METROPOLITAN GOVERNMENT OF NASHVILLE AND DAVIDSON COUNTY

STAFF RECOMMENDATION
3618 Westbrook Avenue
May 15, 2013

Application: New Construction—Addition
District: Richland-West End Neighborhood Conservation Zoning Overlay
Council District: 24
Map and Parcel Number: 10405021900
Applicant: James Lowen
Project Lead: Melissa Baldock, melissa.baldock@nashville.gov

Roof Plan

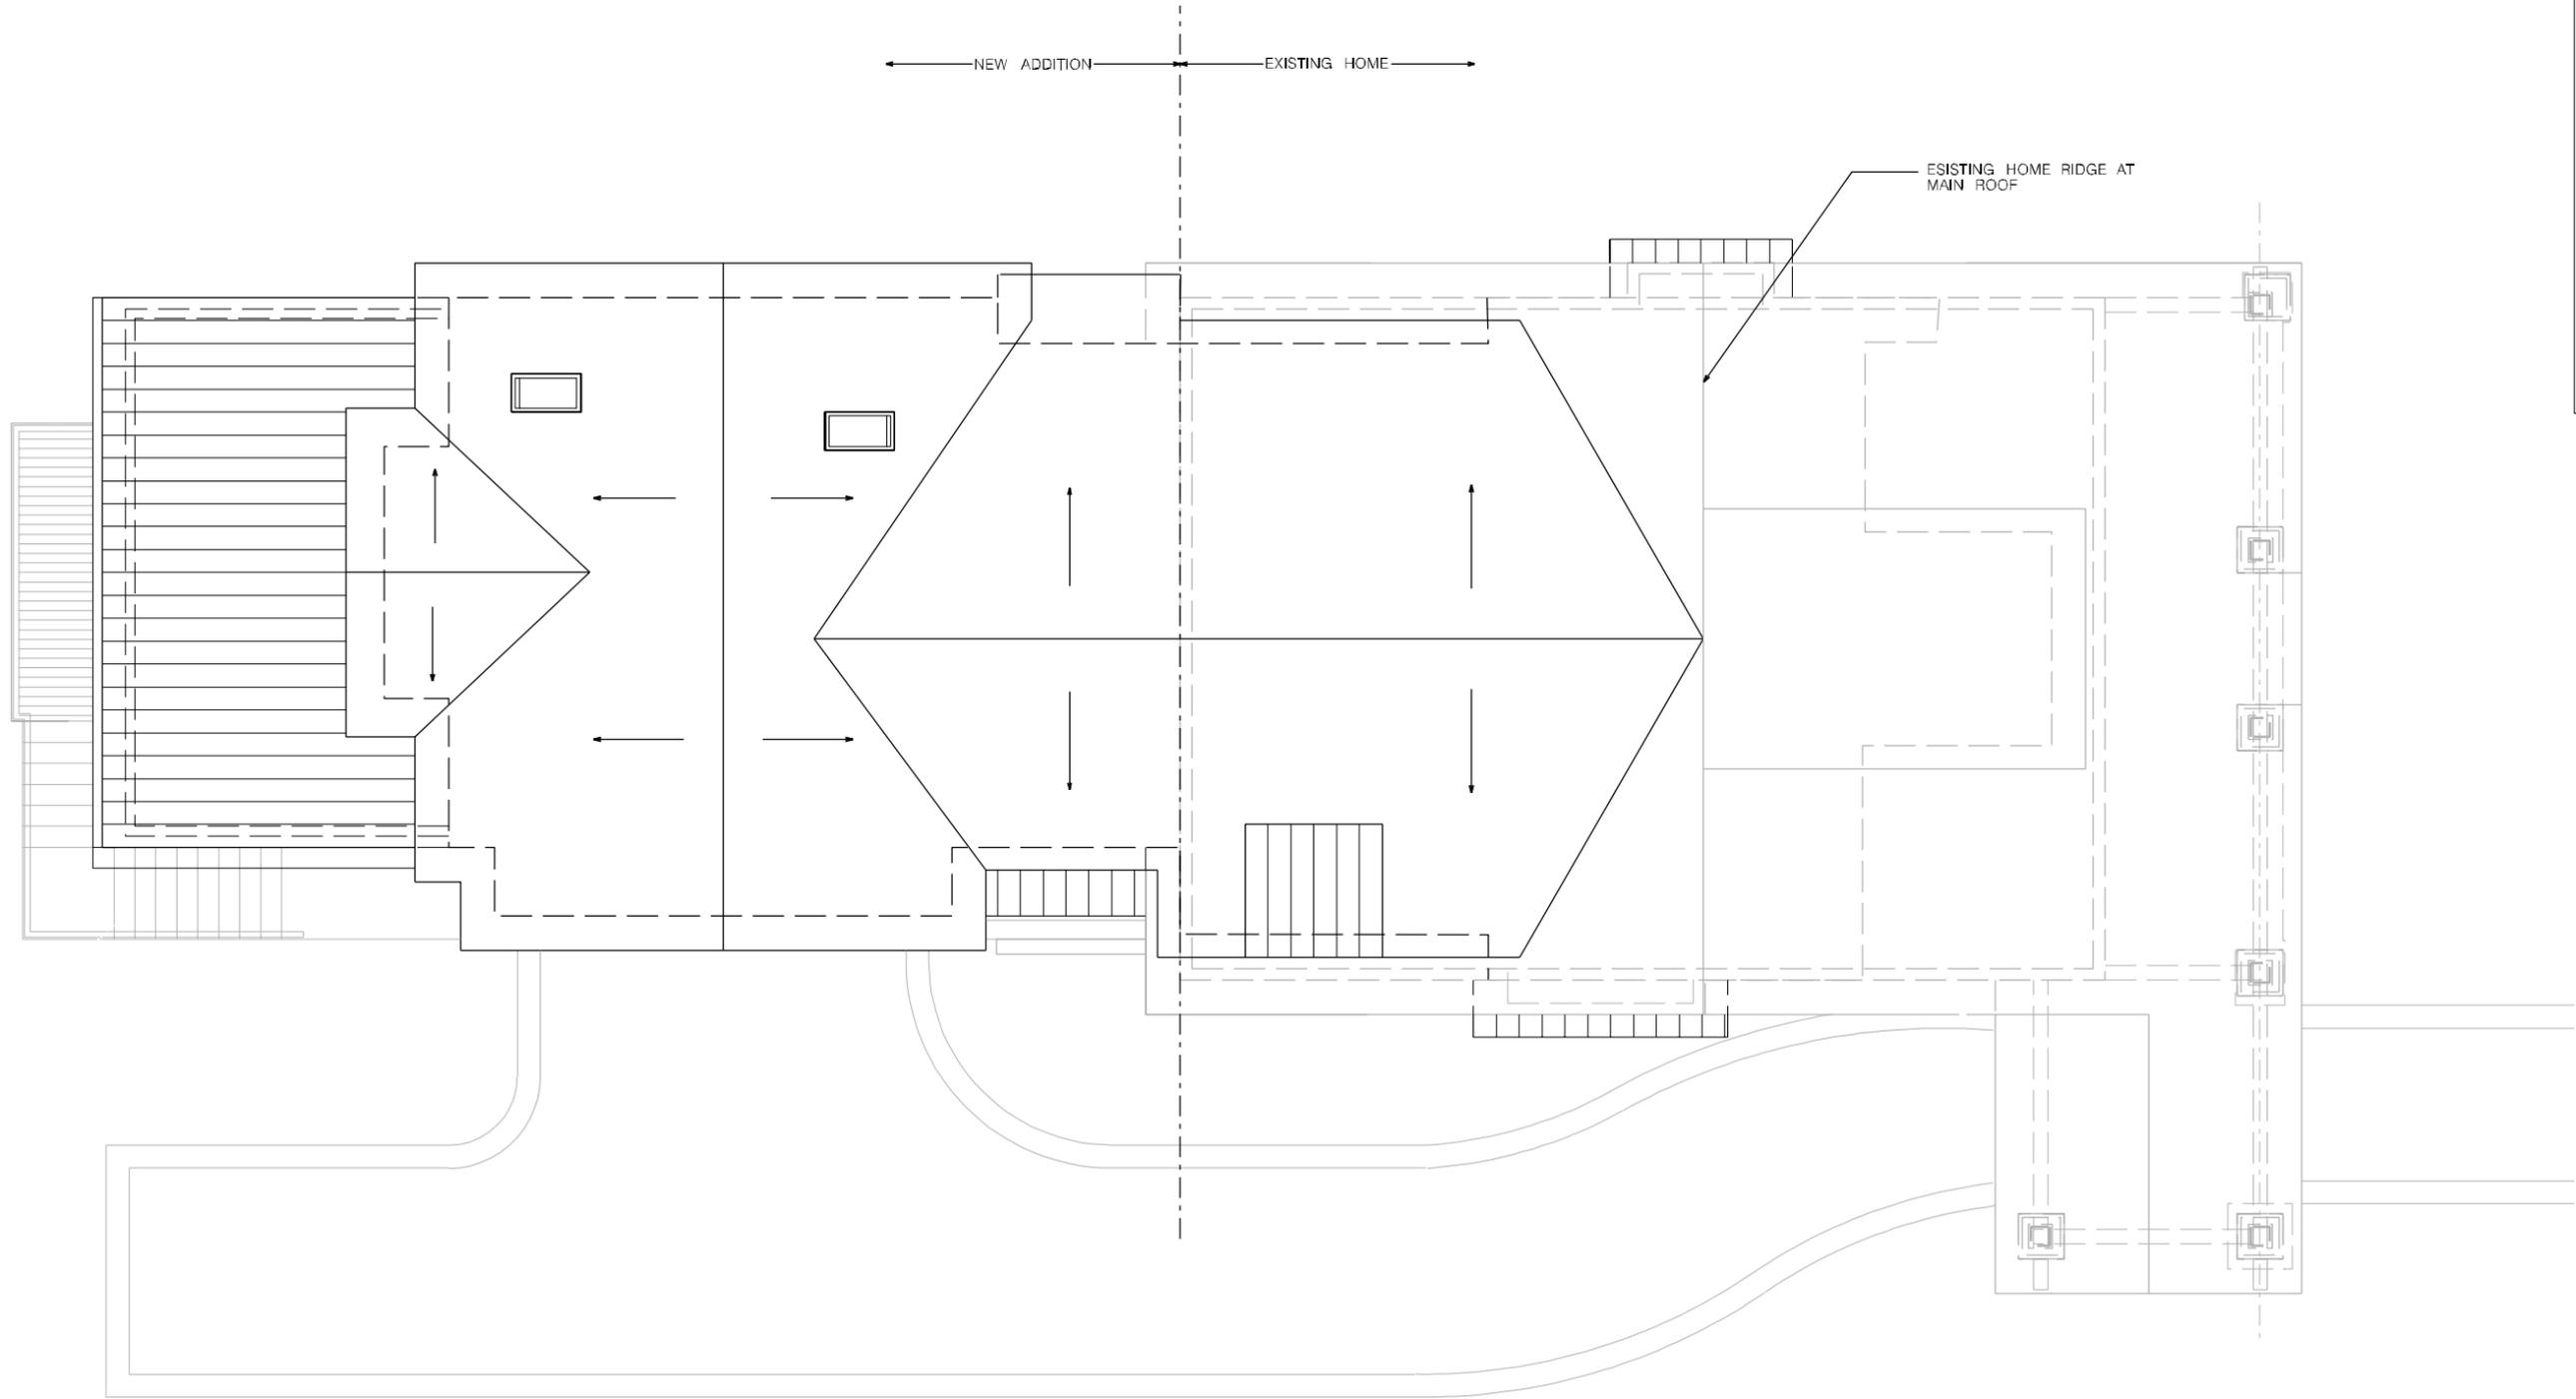
Roofs: The historic house has a side gable roof form with a slope of 5/12. The addition's roof form will also be gabled with a 5/12 roof form. The rear porch will have a shed roof with a slope of 3/12. The left façade of the addition has a shed dormer, and a gabled

dormer with a 5/12 roof slope is proposed for the rear façade. Staff finds the proposed roof forms for the addition to meet sections II.B.1.e. and II.B.2.a. of the *Richland-West End Neighborhood Conservation District: Handbook and Design Guidelines*.

Side Elevation

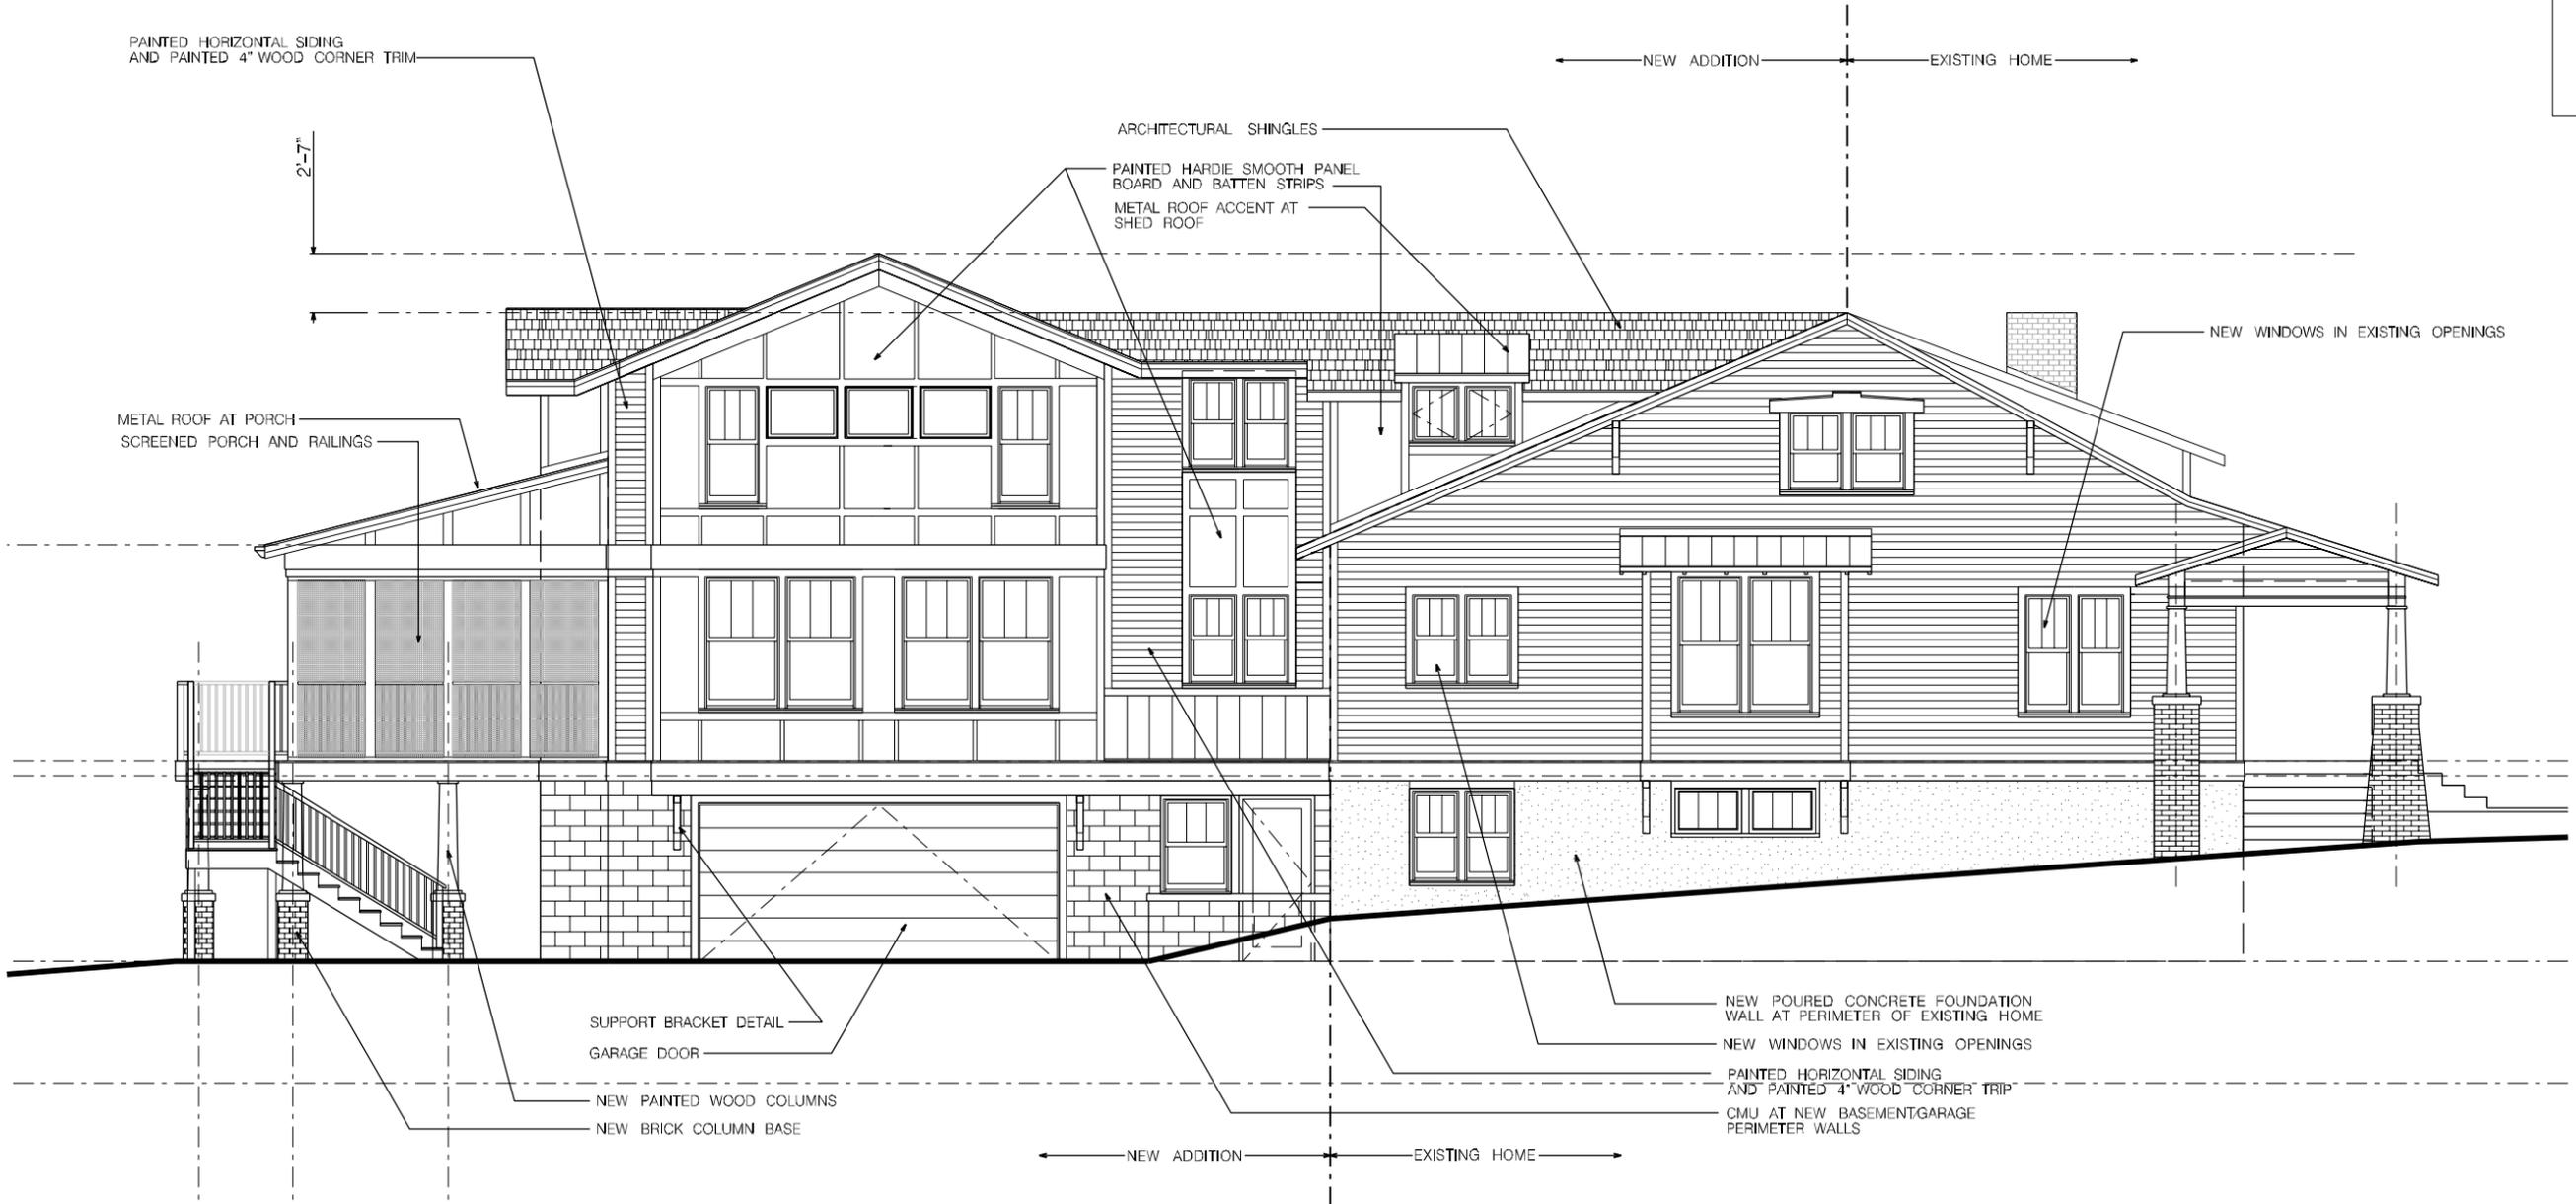
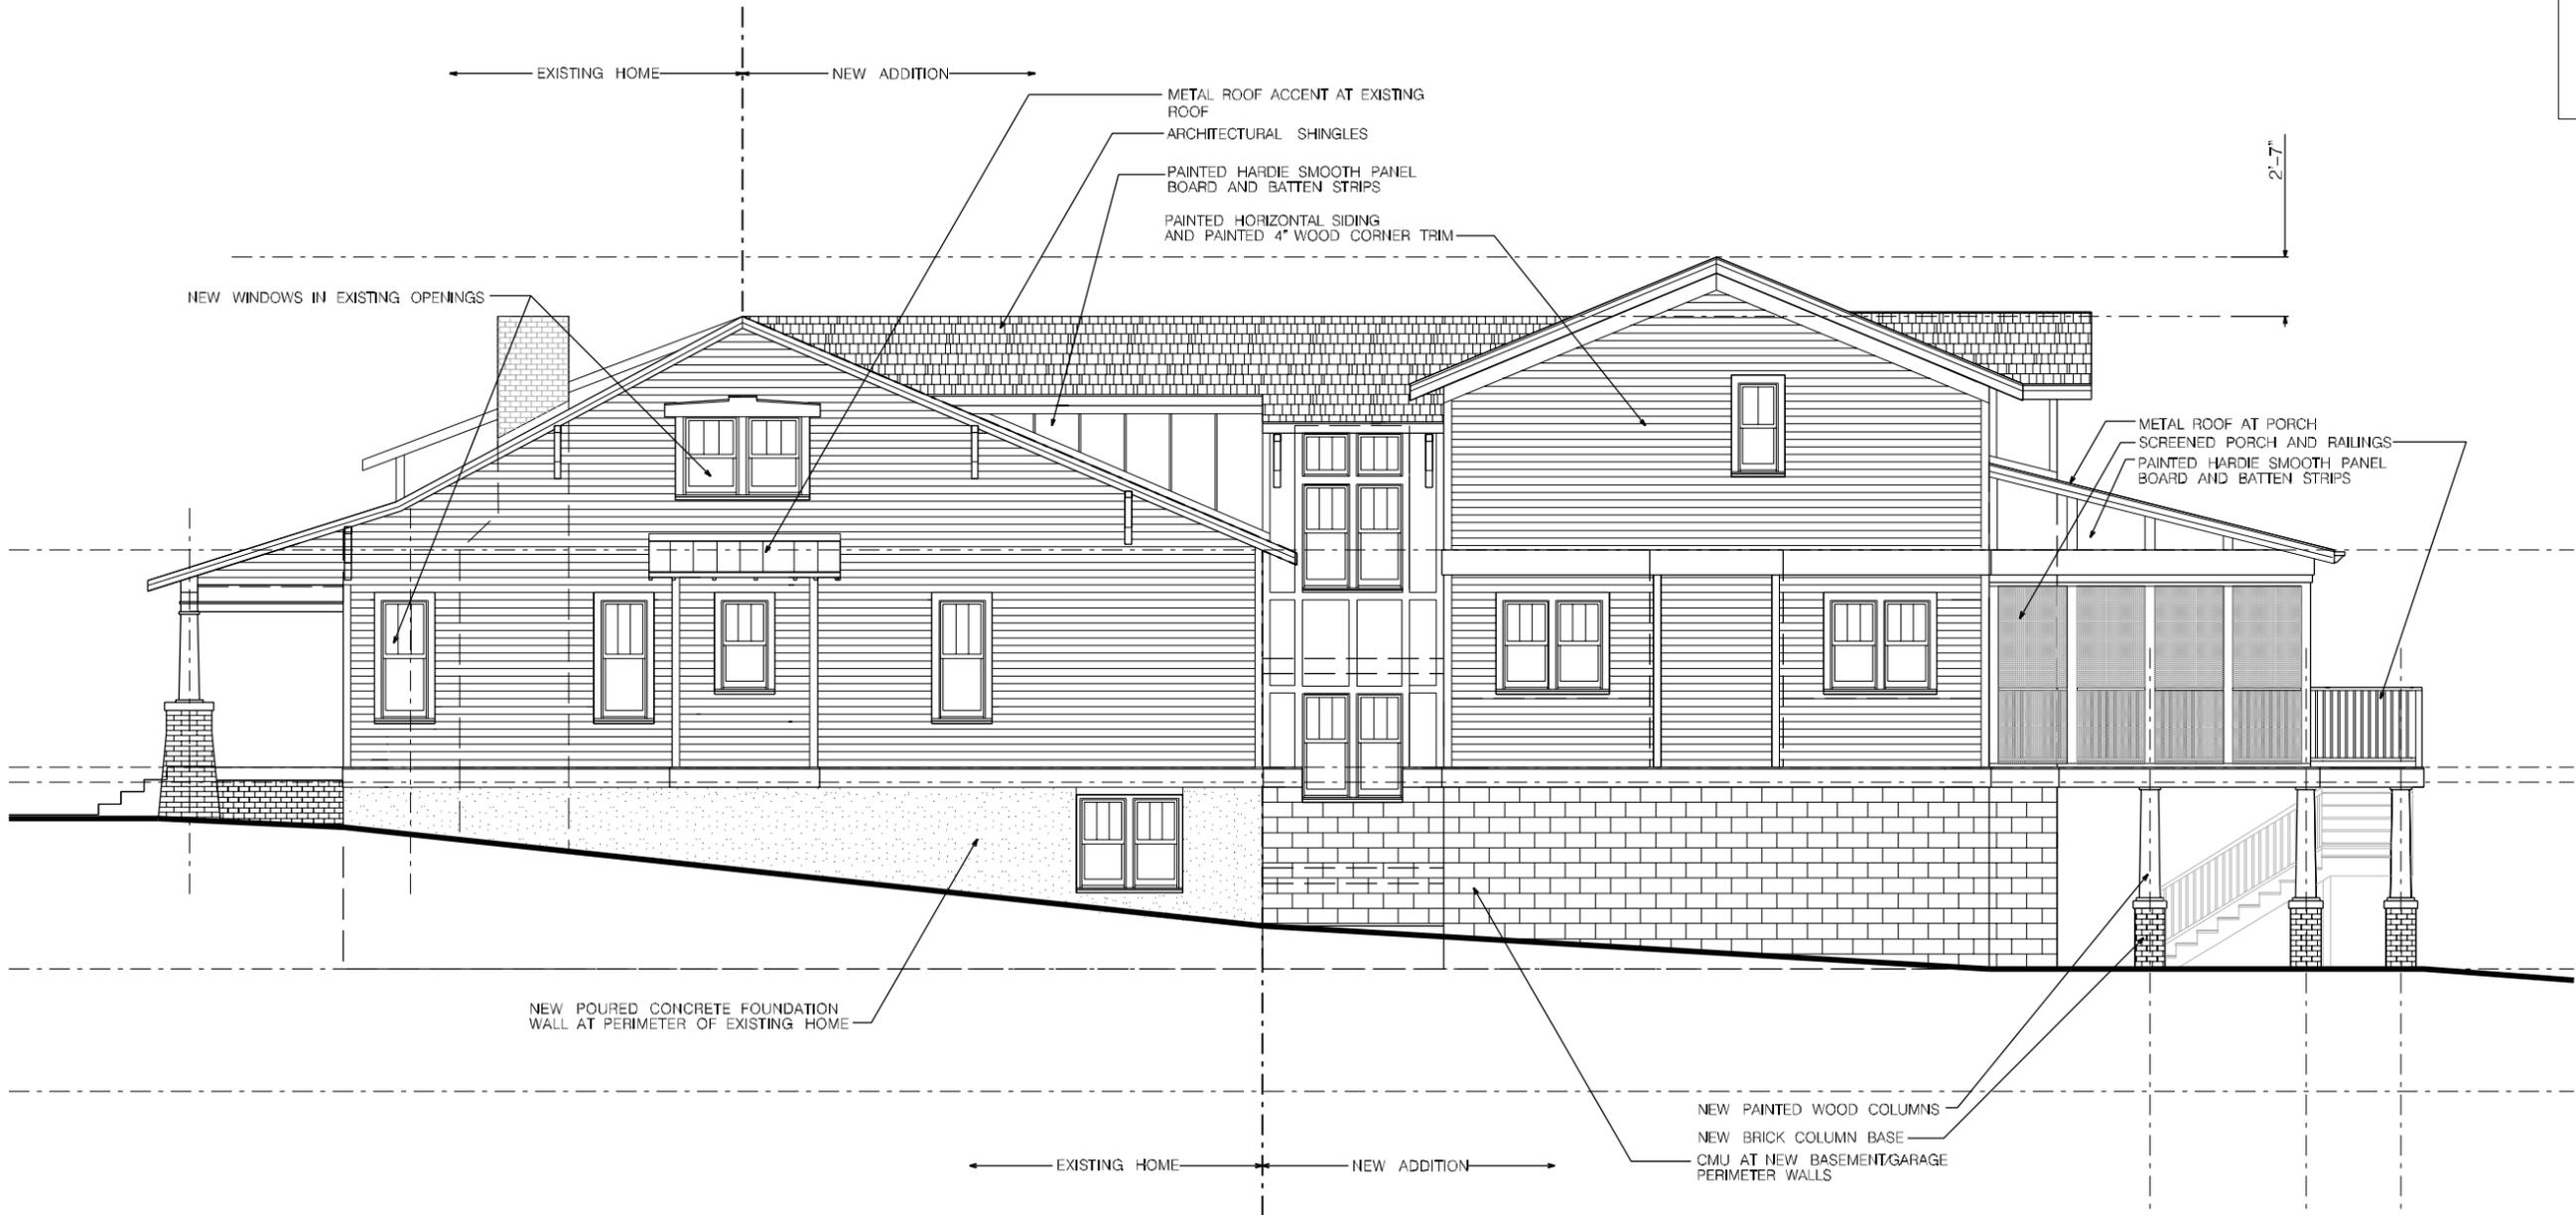
An analysis of the drawings indicates that the applicant may be altering the window openings on the historic house, which can be considered to be partial demolition. Staff asks that a condition of approval be that the applicant submit revised elevations that show which window openings will be altered as part of the project.

The two-story addition steps in from the historic house appropriately. On the right side, the addition steps in two feet (2’) for a depth of approximately eight feet (8’). After that inset, the addition comes back out to line up with the left side wall of the house. On the left side, the enclosed addition space is inset six feet (6’) from the sidewall of the house.

The addition ties into the ridge of the house and continues at this height for a distance of approximately thirty-five feet, six inches (35'6"). After this point, the addition increases in height to be two feet, seven inches (2'7") taller than the existing house. Staff finds the increased height of the addition to be appropriate because it does not occur until more than sixty feet (60') behind the front of the porch, because it has a side gabled roof form that minimizes the visual perception of the height, and because it is only two feet, seven inches (2'7") taller.

1. The applicant submit revised elevations that indicate how the window openings on the existing house will be altered.
2. The concrete foundation wall on the house have a parge coat and the foundation on the addition either be split-face concrete block or smooth face block with a parge coat.
3. Staff review and approve the shingle and metal roof color, brick samples, and all window and door specifications.
